Reference Number: FOI202223/300
From: Private Individual
Date: 15 September 2022
Subject: Documentation relating to 2022 planning permission granted for MUGA to be built in Springfield Park.

Q1 All documentation relating to 2022 planning permission granted for Multi-Use Game Area (MUGA) to be built in Springfield Park.

- A Exit from car park, inc blue badge
- B Park route to McDonald house
- C MUGA with external hoop
- D Outdoor gym
- E Youth shelter
- F Swale
- G 10m set back
- H Hedge to separate McDonald House pedestrian route

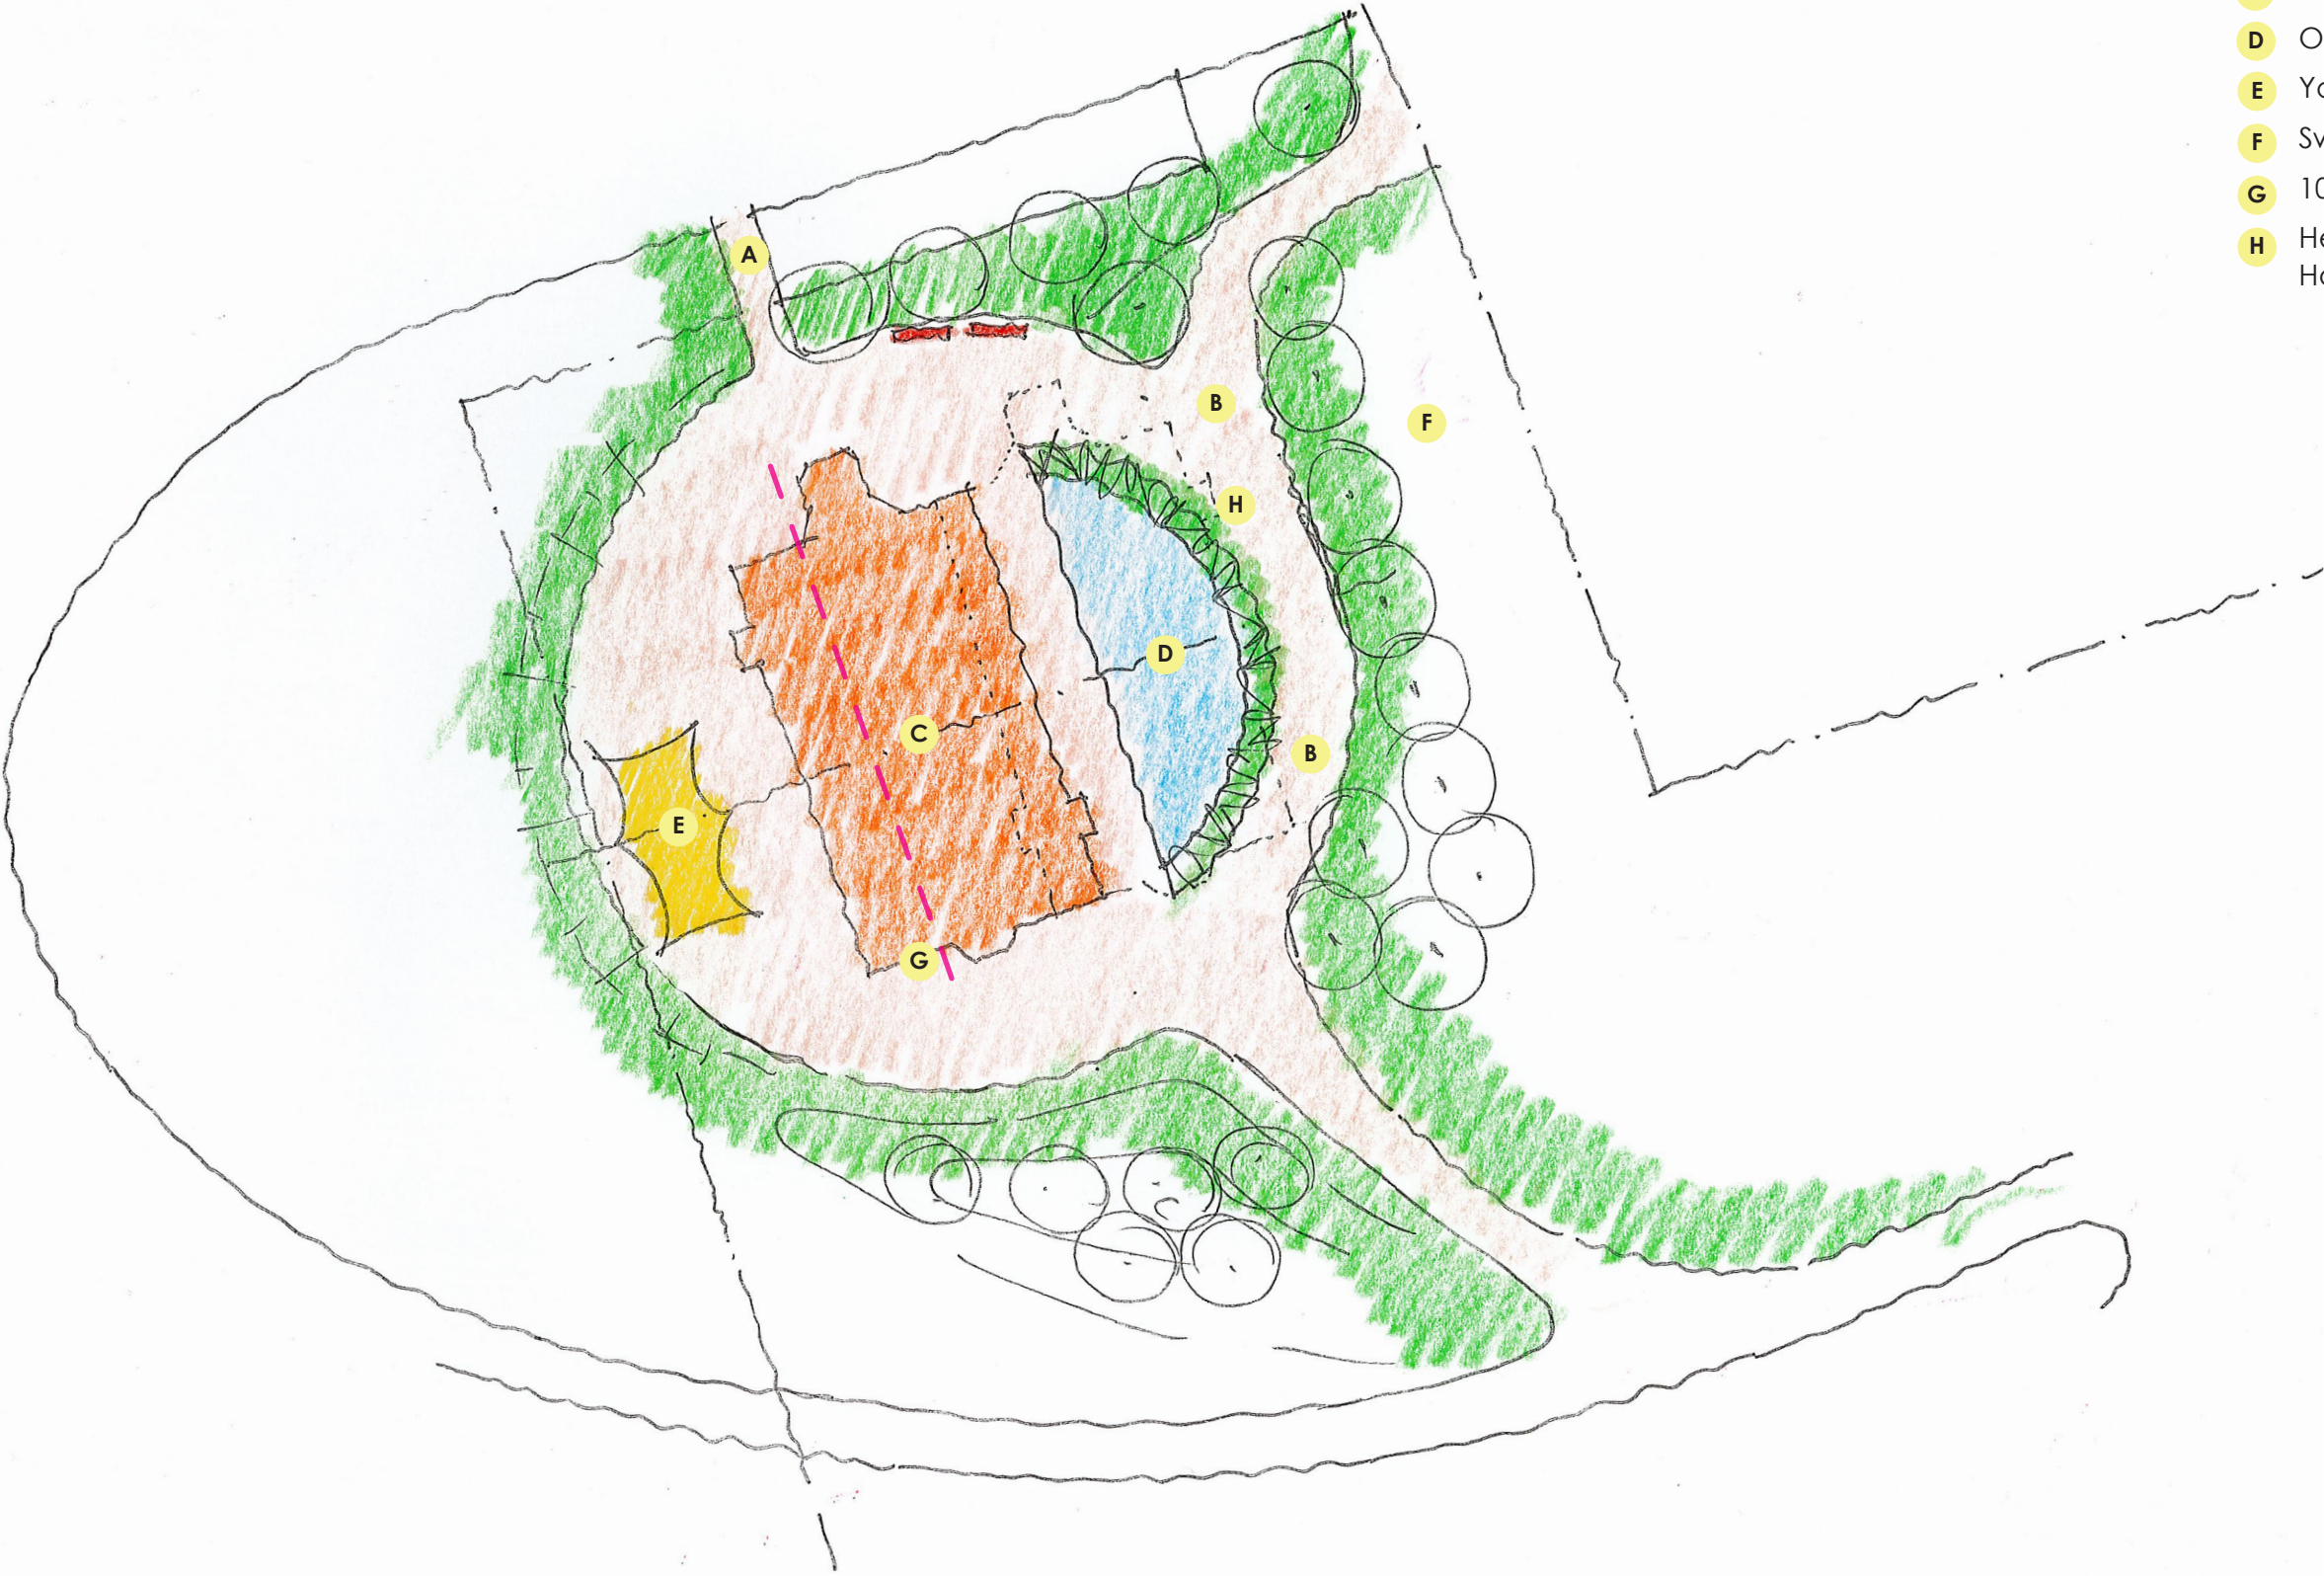
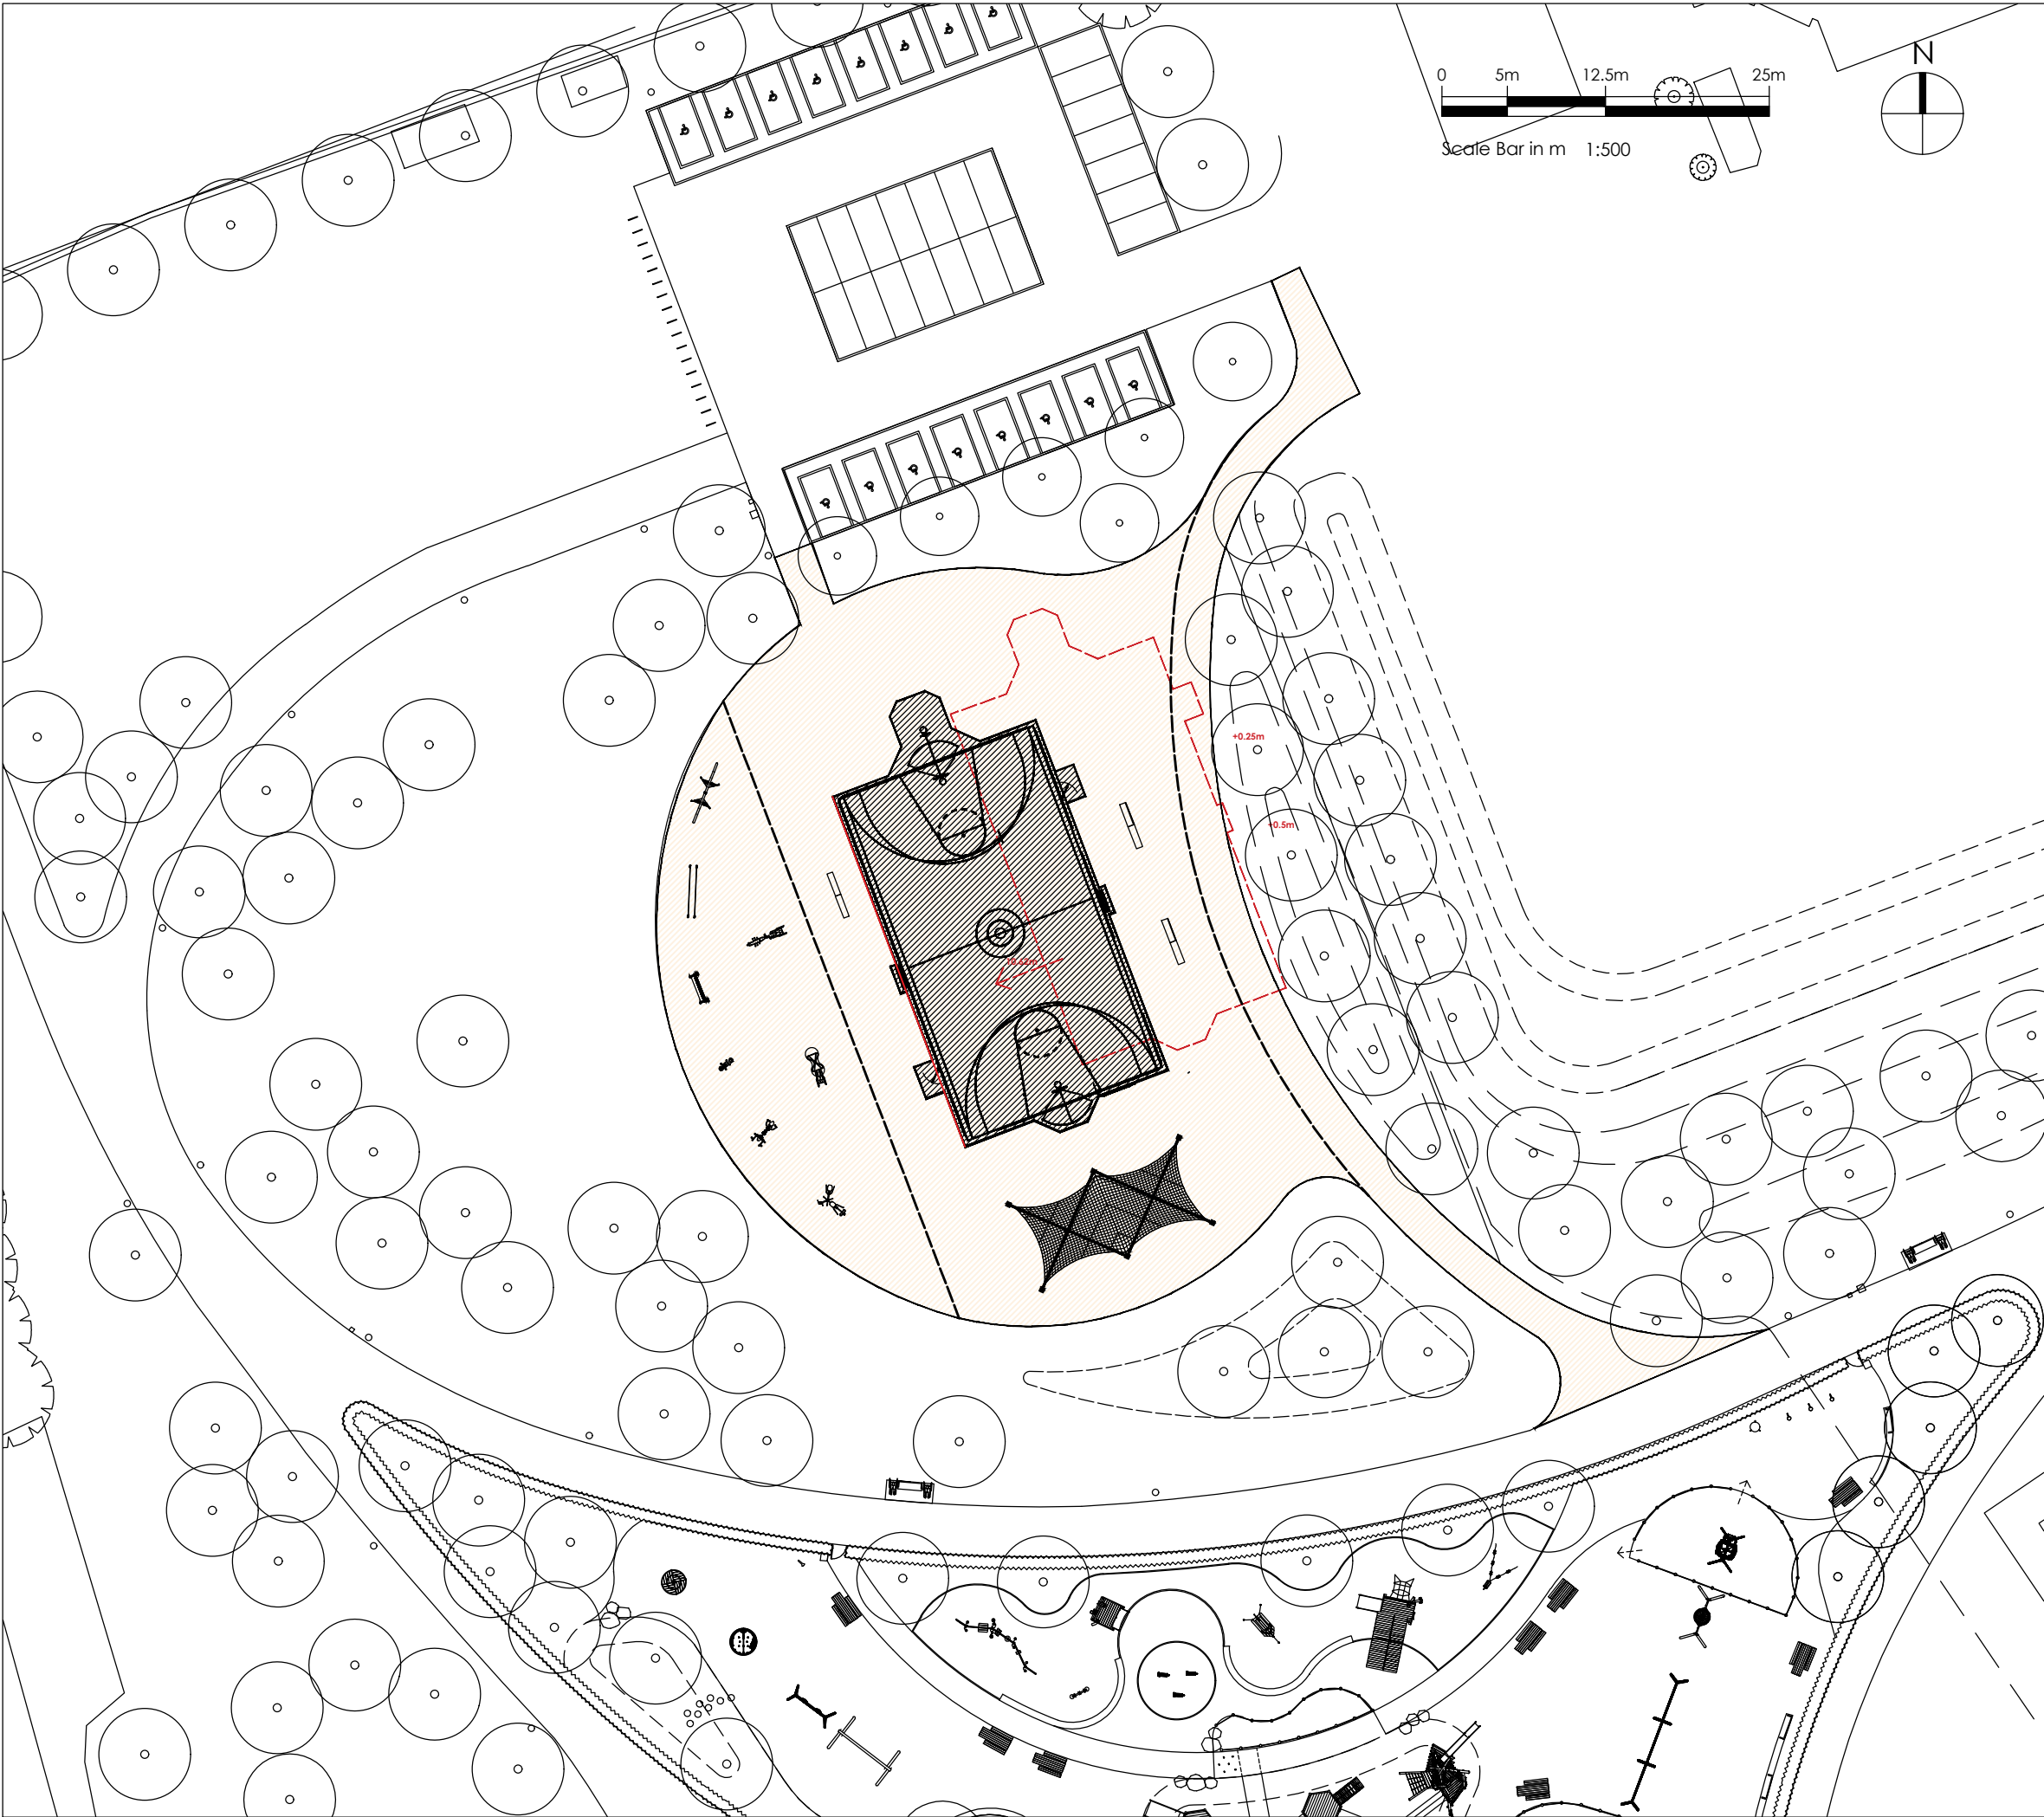
Thanks for the plans. However, I would need to understand the site locations in the wider context of the site. If you could plot the proposed locations of a site location plan, so I can assess the implications on surrounding properties and consented properties. It is hard to fully understand the locations on the plans submitted, as they are submitted in isolation. If you could do this, I would then be able to comment fully.

I am happy to comment pre submission. The plotting doesn't need to be to full scale, just an indication on a site location plan, so I can get a feel for the relationship.

Figure 4-2 – Indicative location of noise barrier

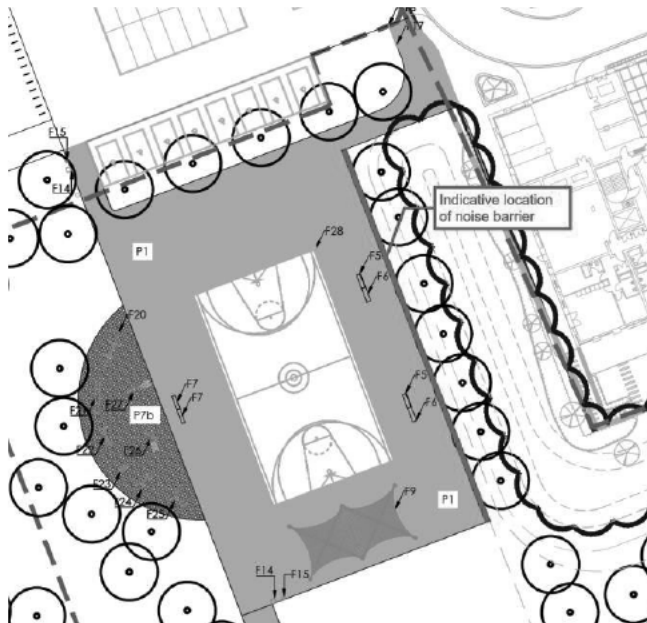
The WSP report also suggests that erecting a 3 metre high noise barrier (see Figure 4-2 of the report) would provide a further 3 dB reduction in predicted noise levels from the MUGA at Springfield Gardens Plot 9. However, there may be adverse visual impacts from such a structure on future residents (it would be about 16 metres away from the west façade of Plot 9, and it would need to be a solid structure to its full height, with no gaps, to be acoustically effective), and since the target noise limits are met (just) without such a noise barrier, I leave it to your judgement as to whether to insist on that element.

Figure C-1 – Noise model plot for MUGA location 1

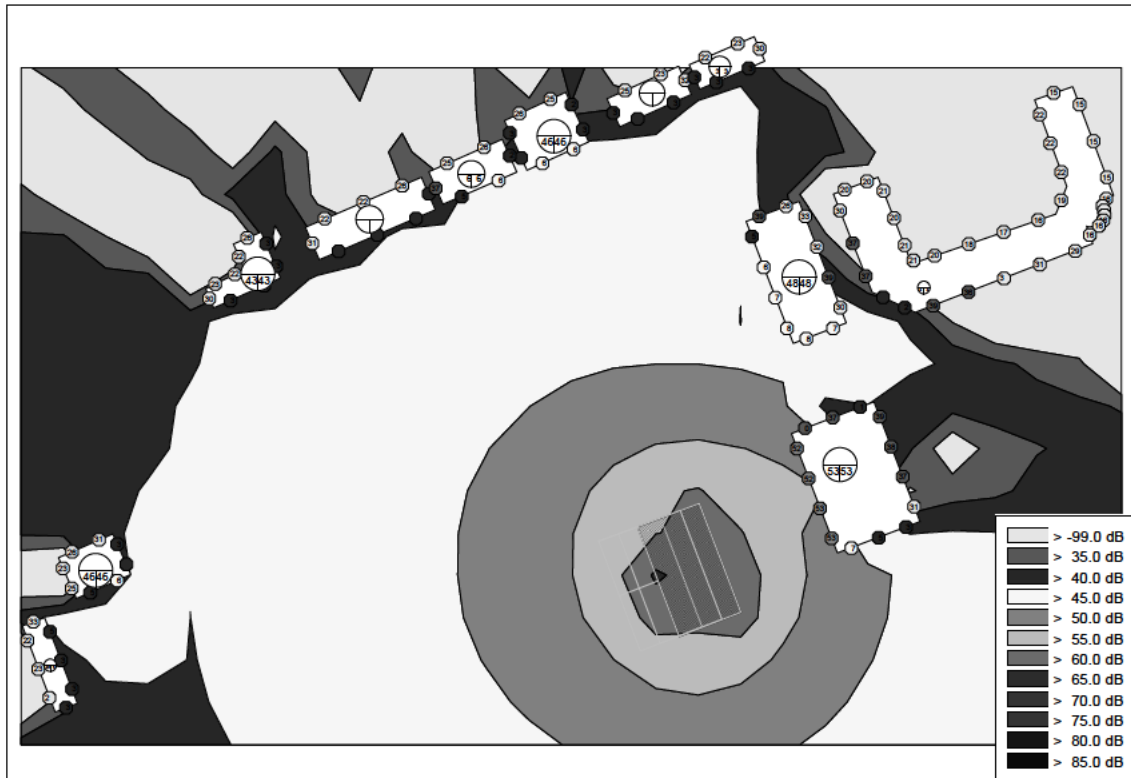
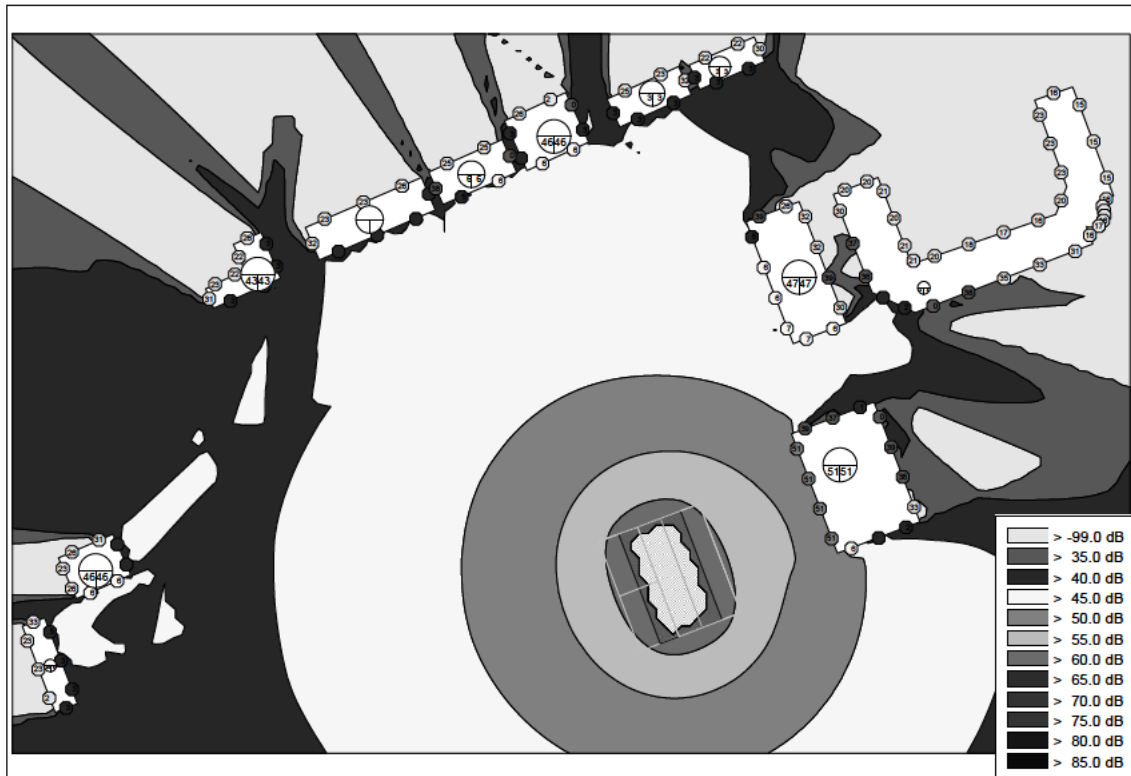
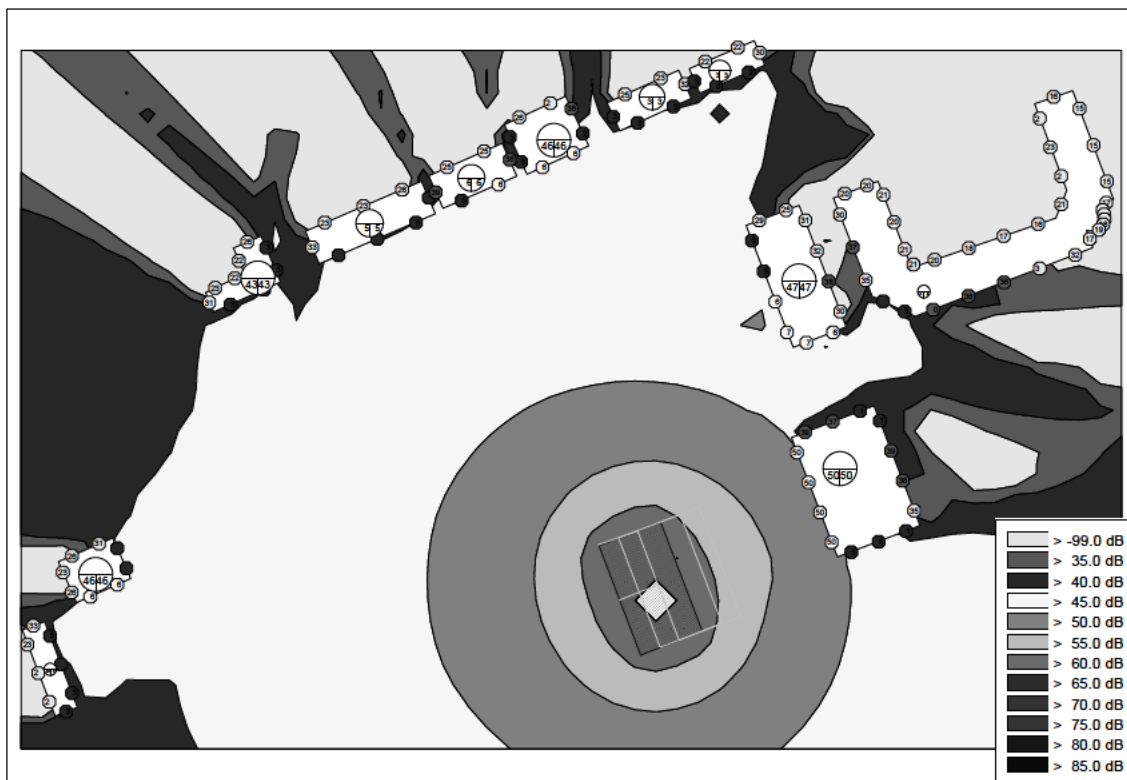
I have read the Noise Impact Assessment by WSP. It reports on noise modelling for three potential locations for the MUGA – the position as shown on the submitted MUGA Site Plan

The noise modelling demonstrates that the best position to minimise the noise impact of the MUGA on the nearby Springfield Gardens residential development (Plot 9) would be the westernmost position (10 metres to the position shown in the Site Plan TM391L05#). Placing the MUGA there would reduce the predicted noise levels to fall within the Sport England Design Guidance Note recommended noise limit of 50 dB(A).
